Reliability Analysis Update

Transmission Expansion Advisory Committee

October 6, 2026

Scope / Cost Changes Dominion

B4036.15 Scope Change

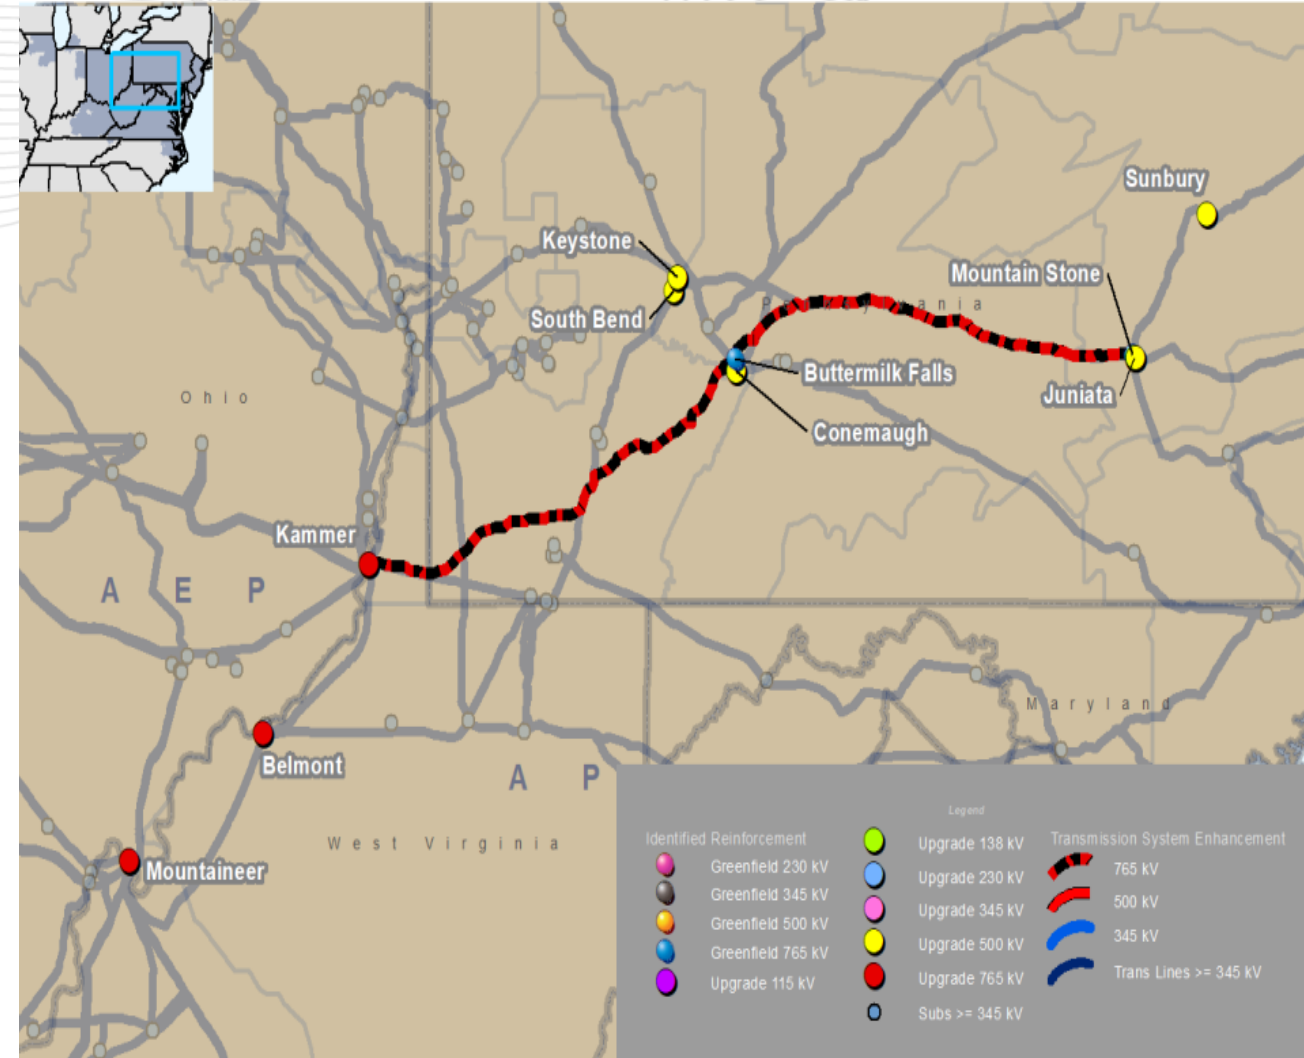
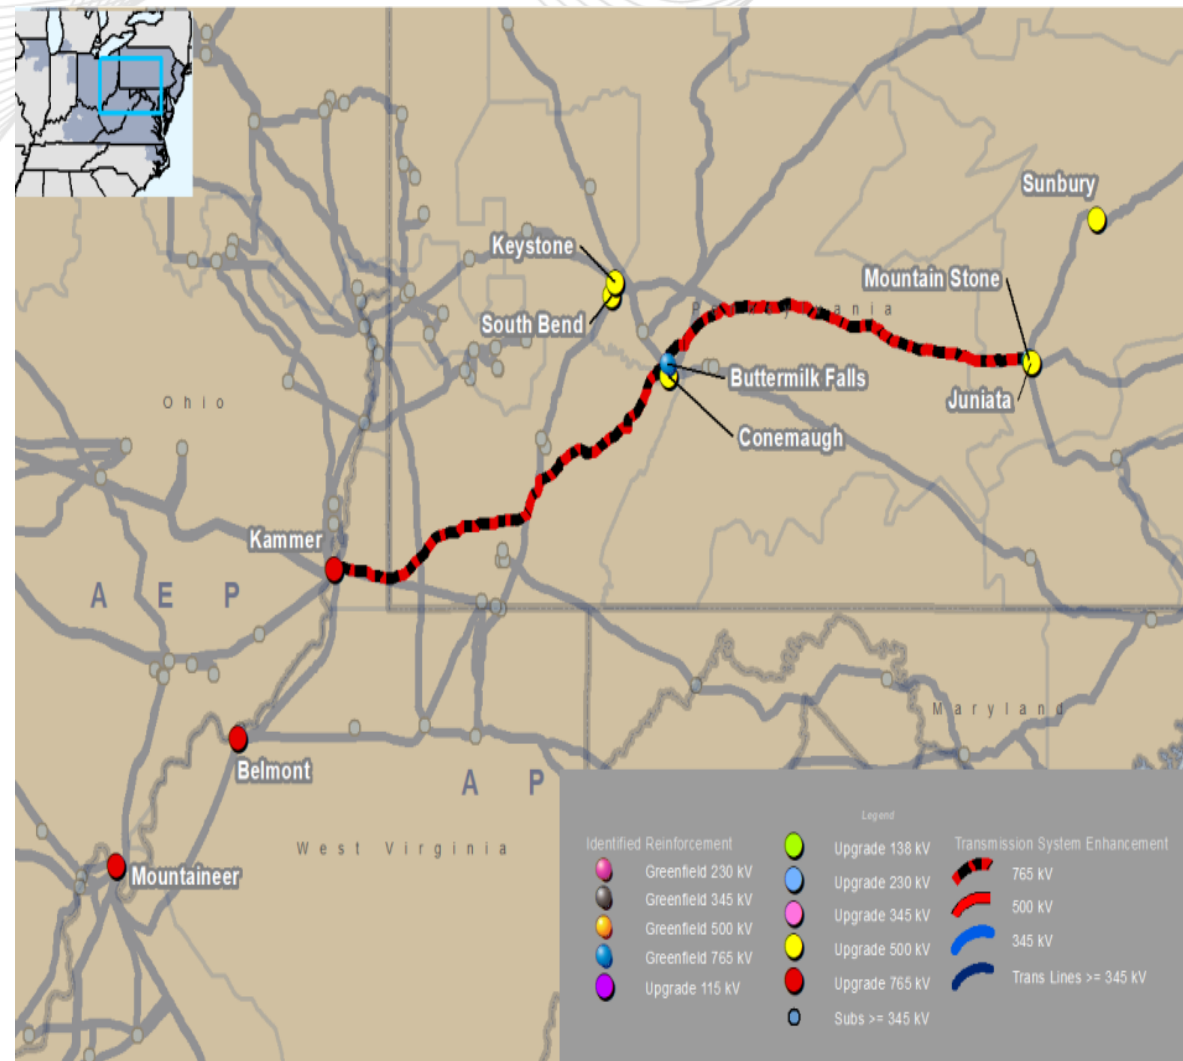
Old Scope: Install two new 500 kV CB at North and South bus to terminate the 765-500 kV transformers leads

PPL has completed its review of the NextEra proposed scope. The evaluation identified broader scope of work than originally anticipated. The additional scope involves constructing a new station adjacent to the existing facility.

The larger scope is required because:

- Bringing the 765/500 kV transformer lead lines into the existing Juniata 500 kV buses would cause thermal requirements that exceed the capability of the existing Juniata 500 kV buses.
- Given outage constraints and the limited footprint of the existing Juniata Substation, it is not feasible to upgrade the existing facility to meet the required rating
- The Juniata 500 kV Substation is already the designated termination point for multiple new 500 kV transmission lines, further limiting expansion and upgrade options

New Scope: Build new Juniata 500 kV station adjacent to the existing Juniata station and re-terminate a portion of the 500 kV transmission lines at the new substation.

New Estimated Total Cost: \$131.53M

B4036.17 Scope Change

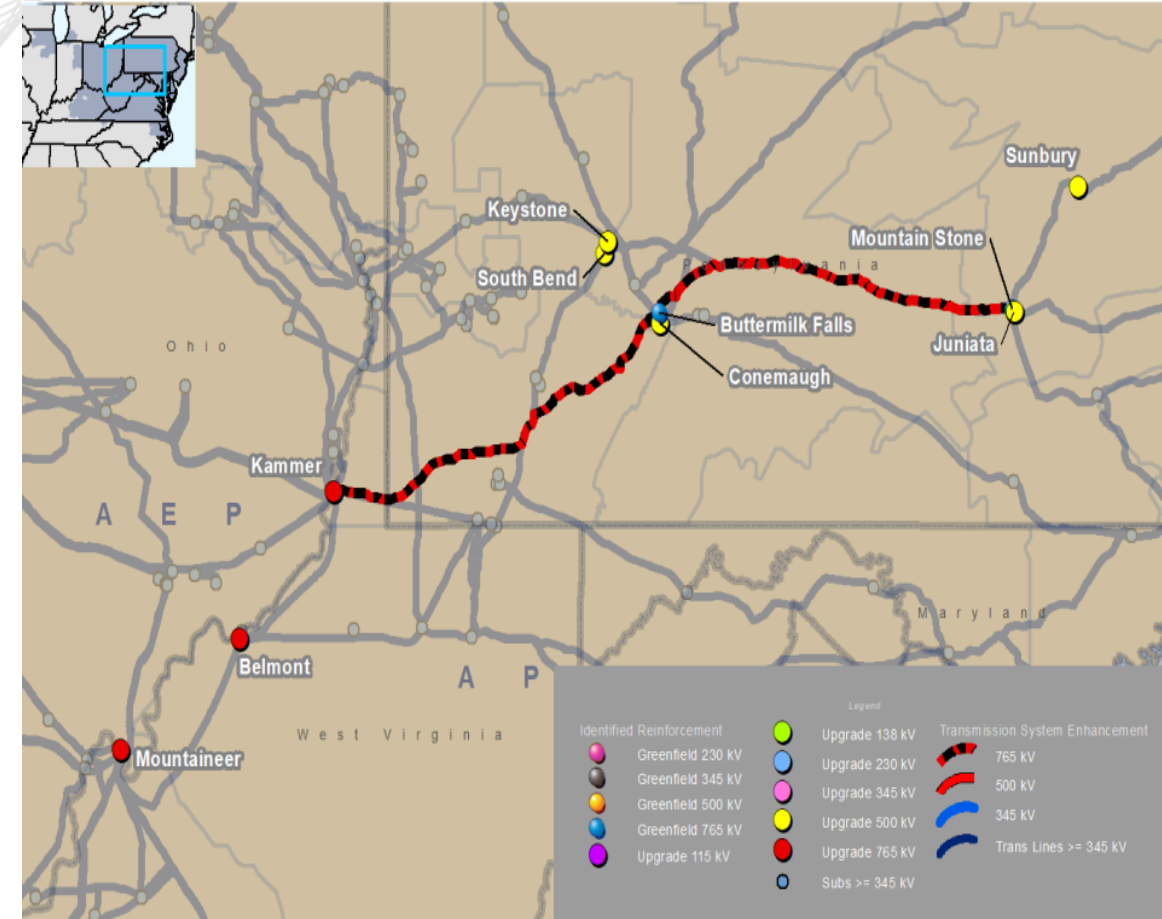
As part of the NextEra approved 2025-W1-237 projects, NextEra submitted a project to reconfigure the Sunbury 500 kV GIS substation. PPL further reviewed the scope and identified additional work is needed

Old Scope : Sunbury - Install two new 500 kV circuit breakers with 63 kA, 5,000 Amps rating in transformer T24 and T25 bay . Both transformers will be in double bus double breaker position after adding these two new breakers.

New Scope: Reconfigure the Sunbury 500 kV substation. Install new 500 kV circuit breaker at bay 4 and move T24 to bay 4 making it breaker and half configuration.

New Estimated Total Cost: \$30M
